ACCESSION NBR: 8404190003 DOC. DATE: 84/04/04 NOTARIZED: NO DOCKET #
 FACIL: 50-275 Diablo Canyon Nuclear Power Plant, Unit 1, Pacific Gas 05000275
 AUTH. NAME AUTHOR AFFILIATION
 SCHUYLER, J.O. Pacific Gas & Electric Co.
 RECIP. NAME RECIPIENT AFFILIATION
 DENTON, H.R. Office of Nuclear Reactor Regulation, Director

SUBJECT: Responds to Board Notification 84-071 issues re draft investigation/insp rept discussed at 840328 & 0402 meetings. Cross ref between issues & util responses encl. Encl info also forwards to ACRS for presentation on 840406.

PGandE Letter No.: DCL-84-131

Re: Docket No. 50-275 OL-DPR-76
Diablo Canyon Unit 1
Response to Board Notification 84-071

Figure 1

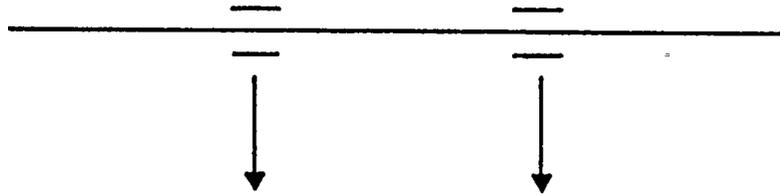
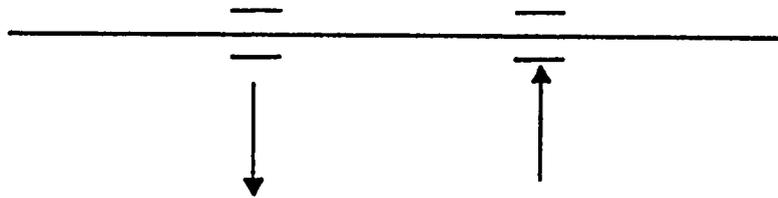
With regard to rigids located in close proximity to rigids, the concern is that if two closely spaced rigid supports (spaced supports with standard construction tolerances of 1/16 to 3/16 inch) have different clearances, then the support with the smaller clearances will have to carry load previously assigned to the support with the larger clearances.

For close proximity supports, there are two mechanisms by which loads are transferred from the piping to the supports. The first mechanism is a simple translational shear reaction, with loads on both supports having the same direction of action. The second mechanism is one where the close proximity supports resist a moment through a force couple. The forces, in this case, act in opposite directions on the two supports. These two mechanisms are represented in Figure 1.

In the case of close proximity supports with zero clearance, the net support design forces are composed of the loads from both mechanisms, with the contribution from the force couple being the dominant component.

In the case where a clearance exists at one or both supports, the effects are twofold:

- The translational shear forces may not be evenly shared.
- The force couple decreases in magnitude as rotation of the piping is not resisted until the clearance is closed.

The actual contributions of the two mechanisms to the support design loads are dependent on specific piping and support configurations. PGandE has examined all of the large bore stress isometrics and identified approximately 140

instances of close proximity rigid supports. From this group, a representative sample has been selected and is being analyzed with consideration of the actual clearances. These analyses will help quantify the actual support load changes.
